ADDENDUM

NO. 1

PROJECT NAME: Tomball ISD Intermediate School Replacement

ADDENDUM DATE: Tuesday, July 28, 2026

2 L1.2 **ENLARGEMENT OF PLAYGROUND LANDSCAPE PLAN**
SCALE: 1" = 10'-0"
01' 5' 10' 20'
SCALE: 1"=10'

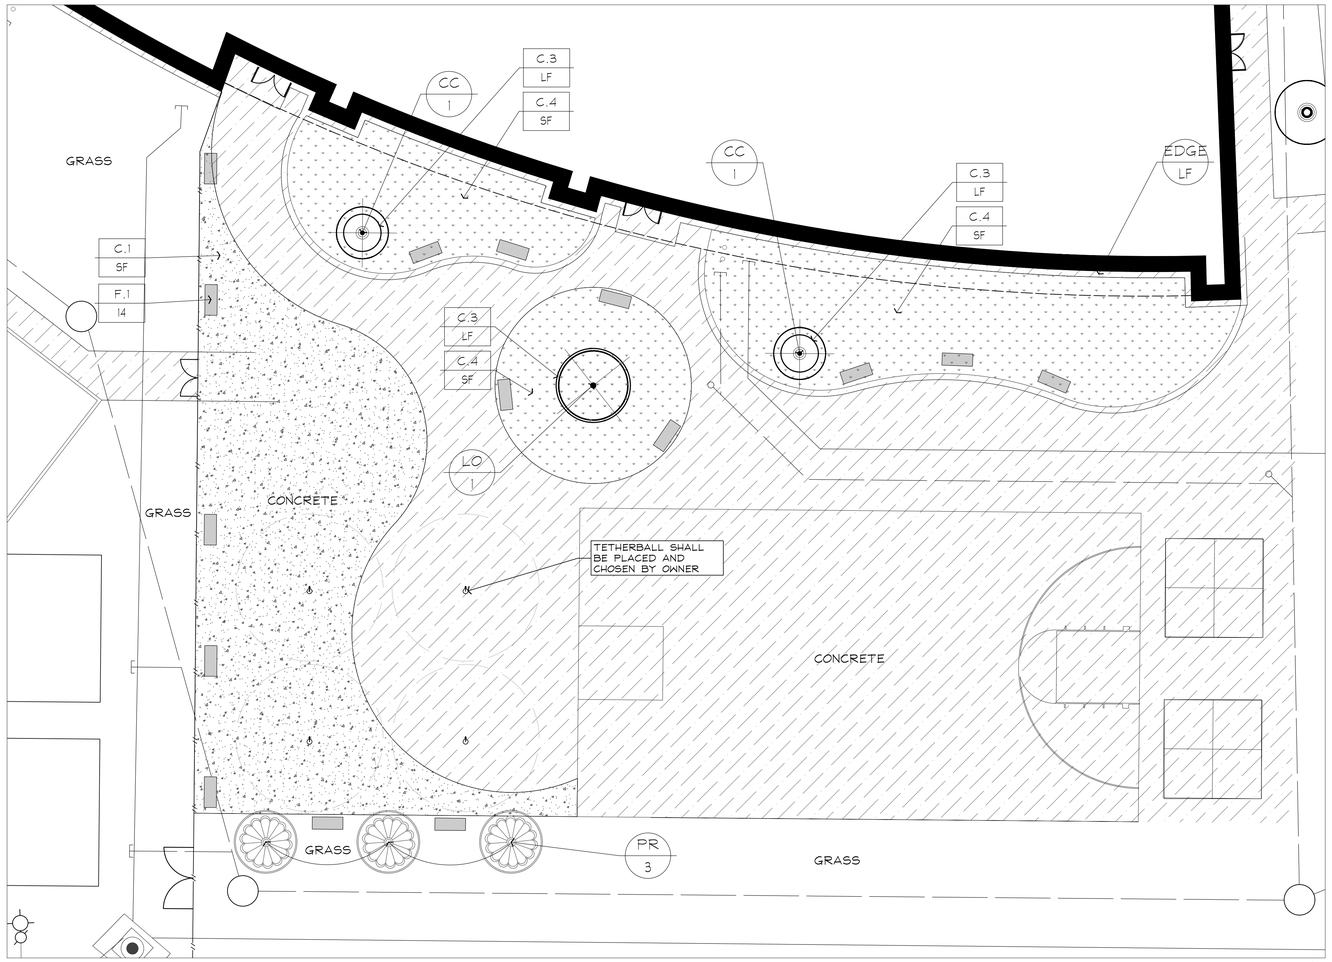
AD No 1, Land Item 1: **To the Drawings, Sheet L1.2, "ENLARGEMENT LANDSDCAPE PLAN"**
Paving and landscape adjusted to coordinate with new fence line. Tree and bench locations have been adjusted to this as well. Landscape and Hardscape legends have been updated with more information on types and finishes.
Details for concrete bench locations and conditions have been added as well as details on artificial turf installation.

1 ROOF FRAMING PLAN - AREA B
S6.07 1/8" = 1'-0"

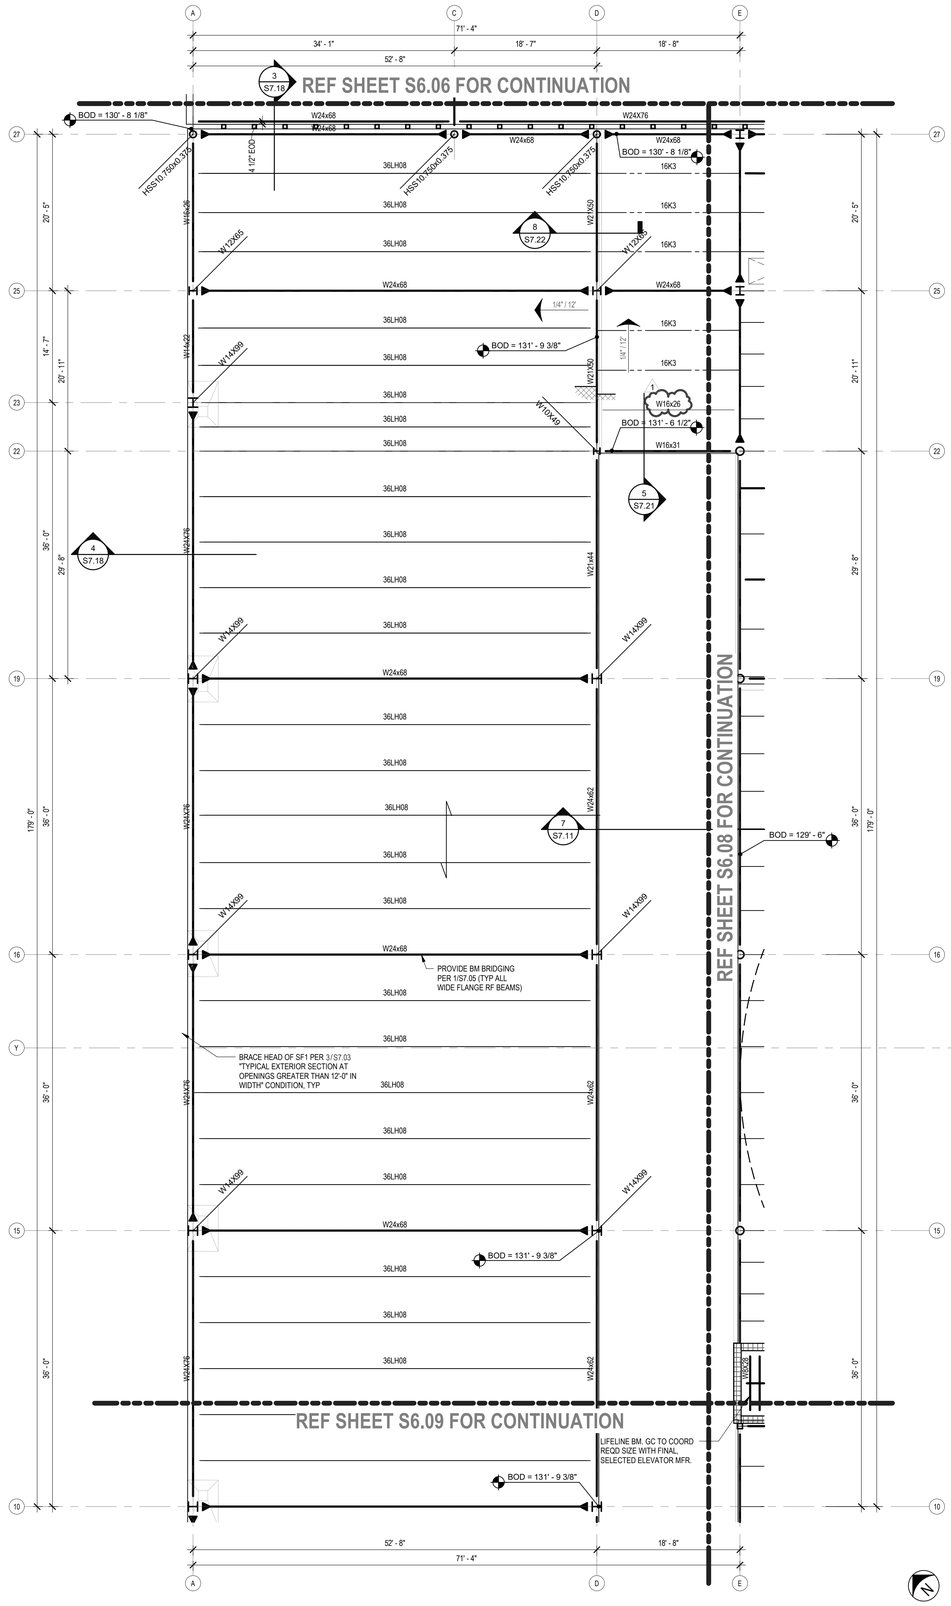
AD No 1, Struc. Item 5: To the Drawings, Sheet S6.07,"ROOF FRAMING PLAN - AREA B"
Changed roof purlin size.

1 ROOF FRAMING PLAN - AREA C
S6.08 1/8" = 1'-0"

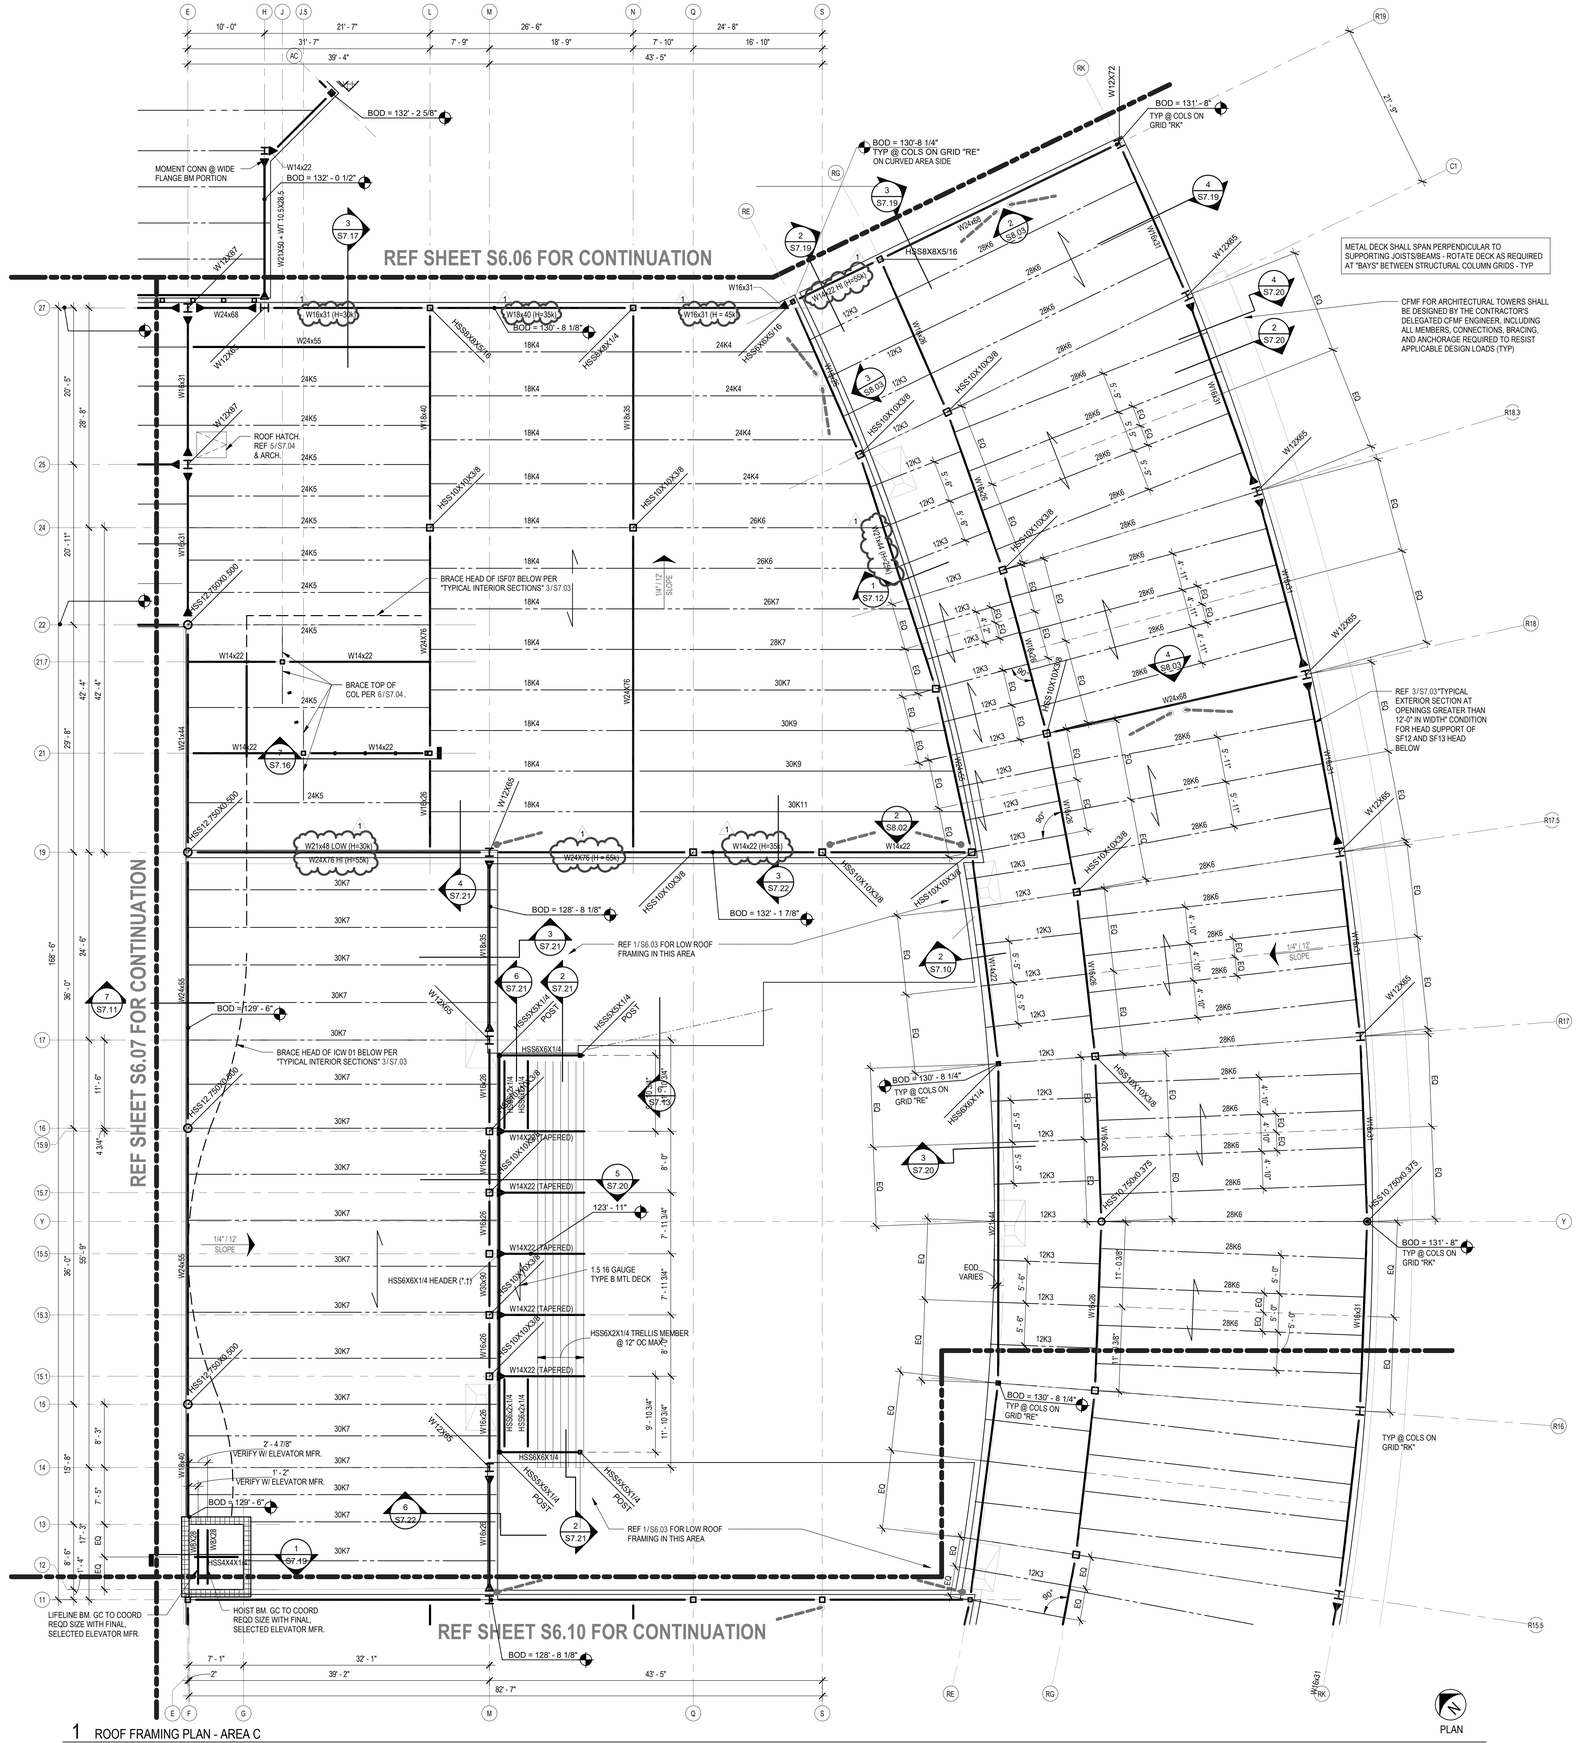
AD No 1, Struc. Item 6: To the Drawings, Sheet S6.08,"ROOF FRAMING PLAN - AREA C"
Added beam axial load notation.

1 ROOF FRAMING PLAN - AREA D
S6.09 1/8" = 1'-0"

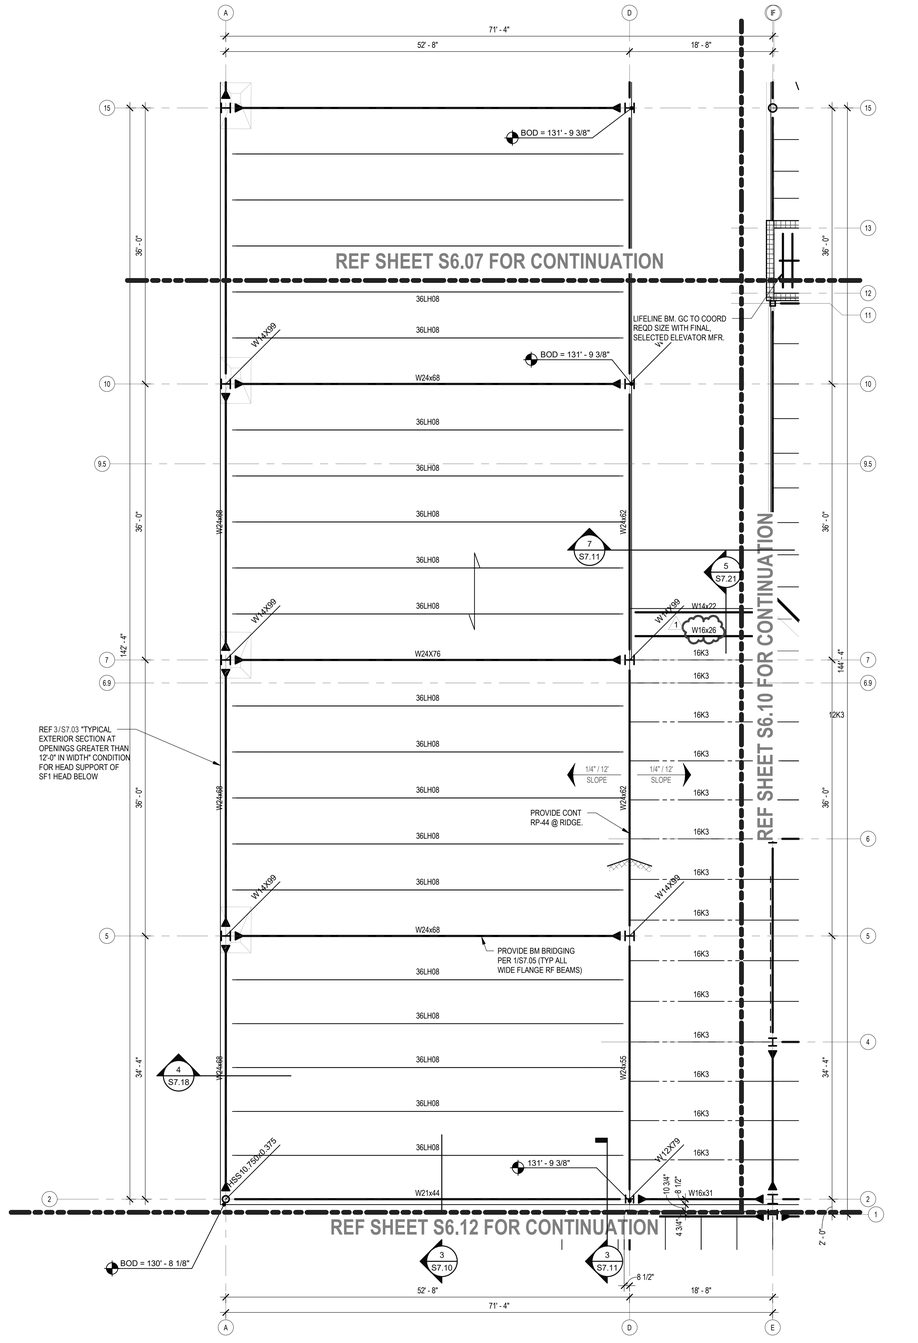
AD No 1, Struc. Item 7: To the Drawings, Sheet S6.09,"ROOF FRAMING PLAN - AREA D"
Changed roof purlin size.

1 ROOF FRAMING PLAN - AREA E
S6.10 1/8" = 1'-0"

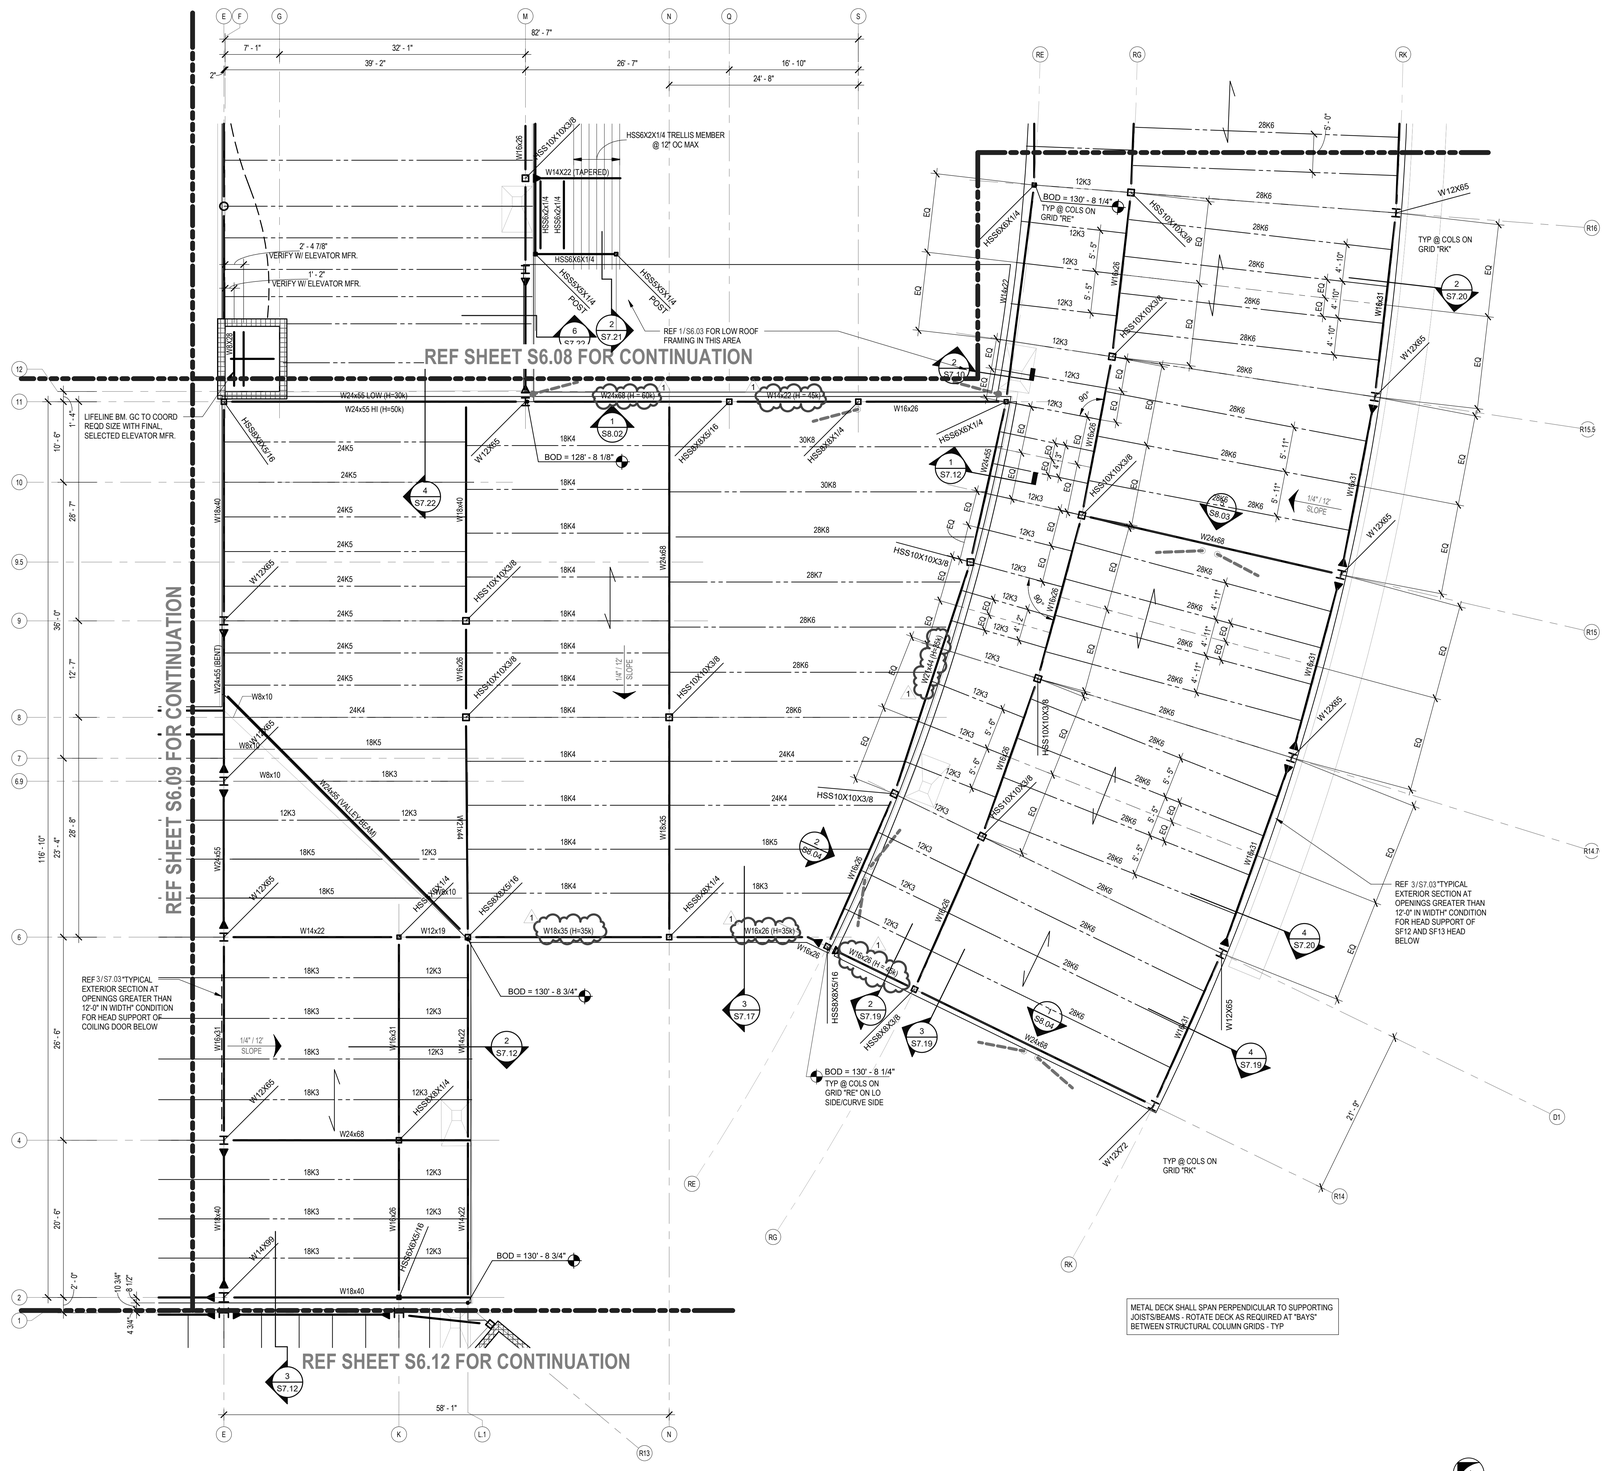
AD No 1, Struc. Item 8: To the Drawings, Sheet S6.10,"ROOF FRAMING PLAN - AREA E"
Added beam axial load notation.

1 ENLARGED FRAMING PLAN - LEARNING STAIR MID-LANDING
S6.13 1/4" = 1'-0"

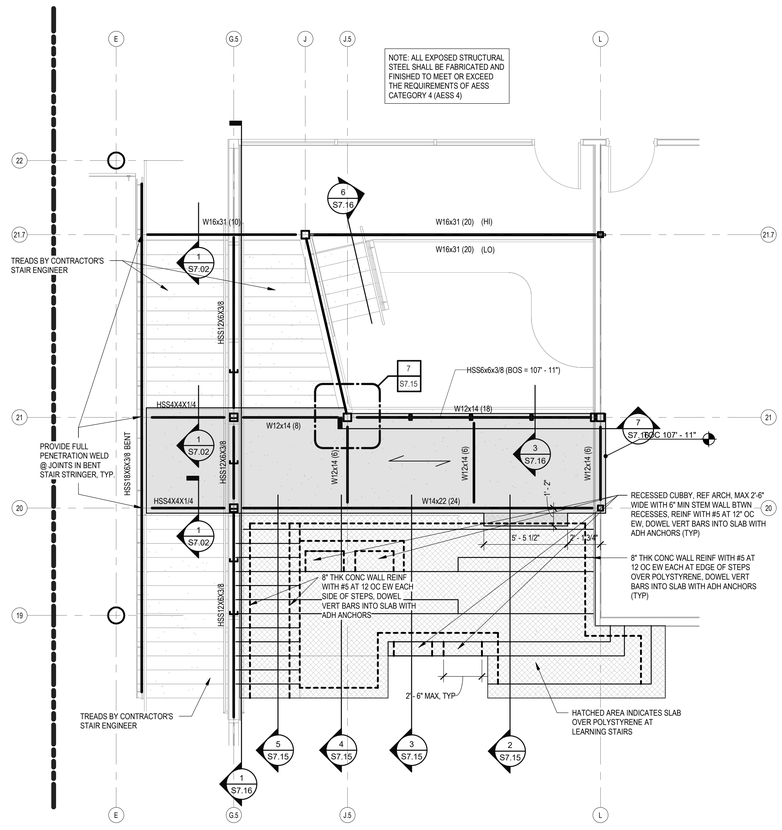
AD No 1, Struc. Item 9: To the Drawings, Sheet S6.13,"ENLARGED FLOOR FRAMING PLANS"
Modified learning stair/nest area.

1 ENLARGED PLAN - ROOF SCREEN
S6.14 1/4" = 1'-0"

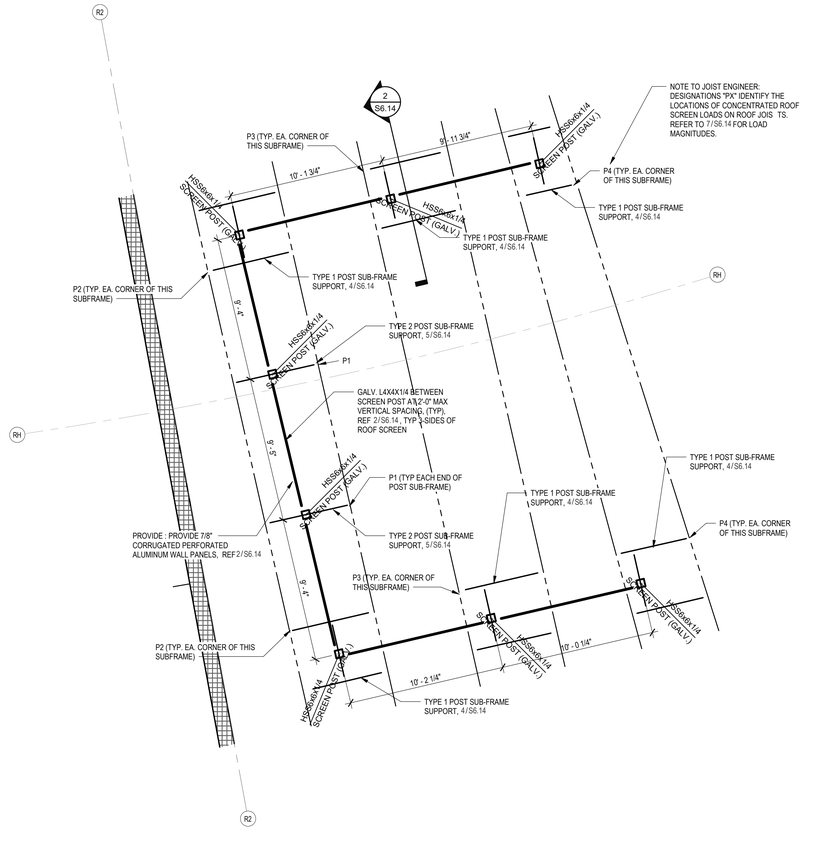
AD No 1, Struc. Item 10: To the Drawings, Sheet S6.14,"ROOF SCREEN PLANS AND DETAILS"
Added new sheet.
